Duluth City Hall Interior Renovations

Phase 1: First Floor

Bid Number: 14-0459

ADDENDUM #2

1 PARTIAL FIRST FLOOR LIGHTING PLAN - SOUTH END
SCALE: 0' 12" = 1'

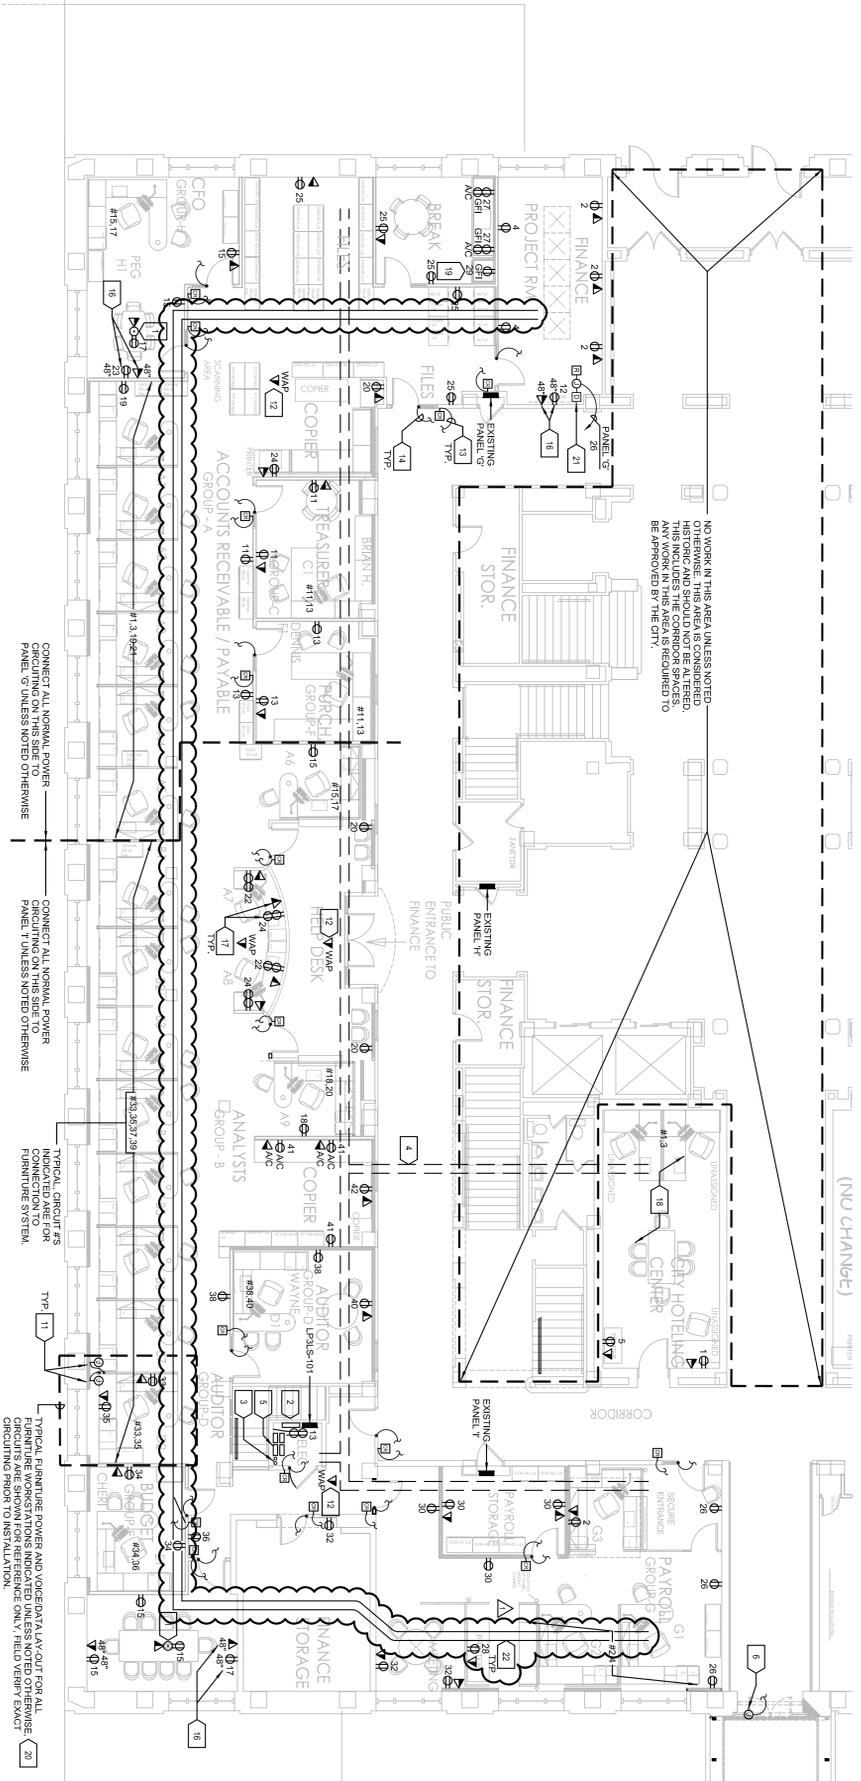
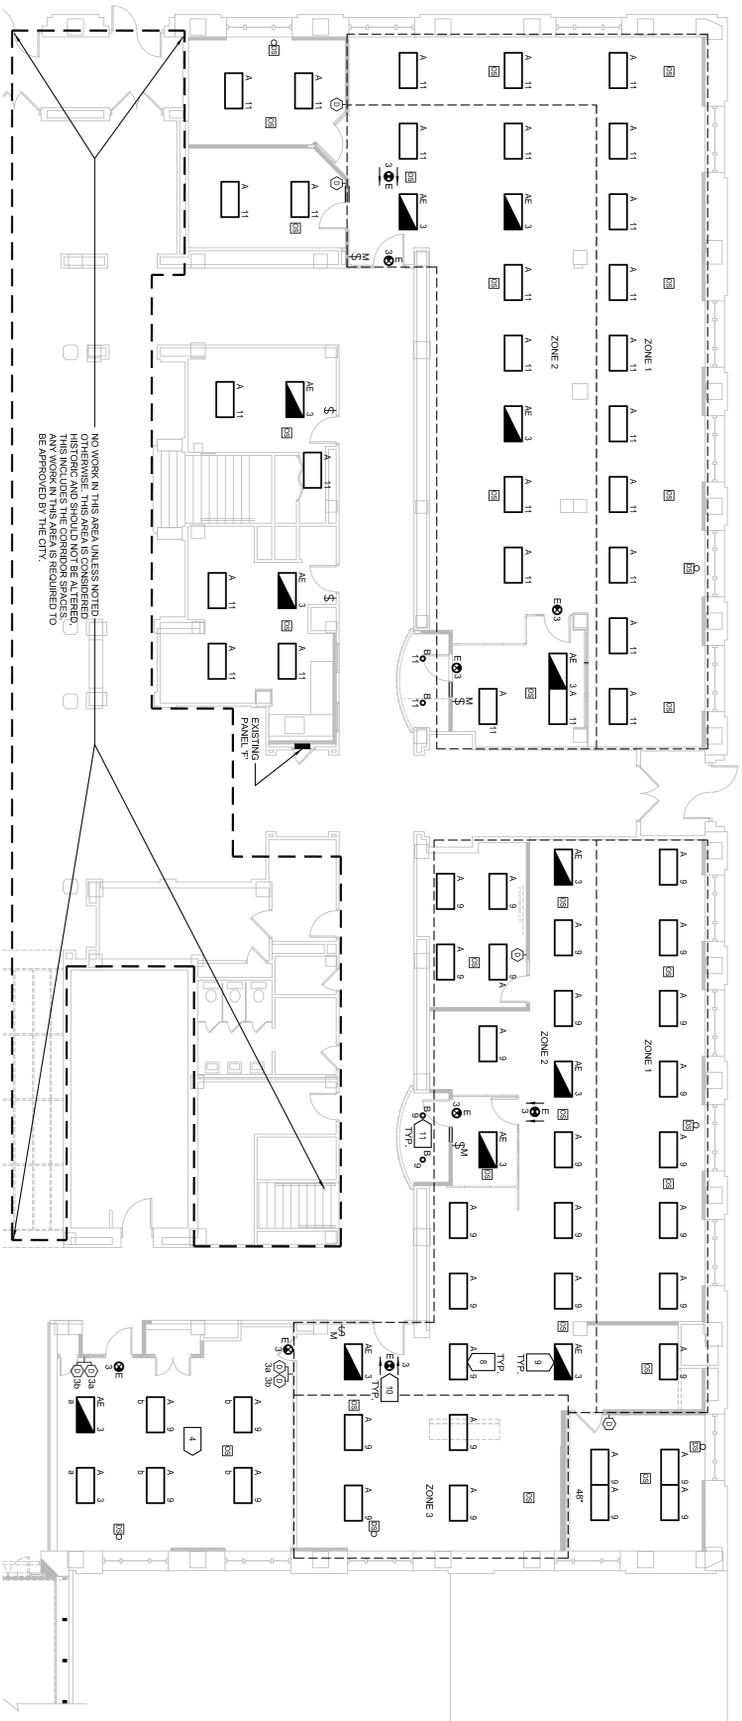
2. Sheet E1.0: Revise Specification as shown clouded on attached plan.
3. Sheet E3.1: Provide new cable tray location as shown clouded on attached plan, as referenced in Addendum 1.
4. Sheet E3.1: Revise numbered note 4 as shown clouded on attached plan.
5. Sheet E3.1: Add numbered note 22 as shown clouded on attached plan.
6. Sheet E3.2: Provide new cable tray location as shown clouded on attached plan, as referenced in Addendum 1.
7. Sheet E3.2: Revise numbered note 3 as shown clouded on attached plan.
8. Sheet E3.2: Add numbered notes 21 and 22 as shown clouded on attached plan.

- TYPICAL, PROVIDE TYPE C LIGHT FIXTURE AS MANUFACTURED BY PHILIPS-DUNN WRITE MODEL, 4835MM OR EQUIVALENT. PROVIDE 3/4" Ø ACCESSIBLE CEILING FOR HOLLOW METAL DOOR FRAME TO ABOVE ACCESSIBLE CEILING FOR DOOR STRIKE AND/OR SENSORS ASSOCIATED WITH DOOR PROVIDED BY OWNER.

- PROVIDE NEW 12" WIRE BASKET MATCH EXISTING STYLE CABLE TRAY AS INDICATED. CABLE TRAY ROUTE IS SHOWN FOR AND NEW SYSTEMS/CONDITIONS. PROVIDE HORIZONTAL AND VERTICAL OFFSETS AS REQUIRED TO FACILITATE EXISTING AND NEW OBSTRUCTIONS.
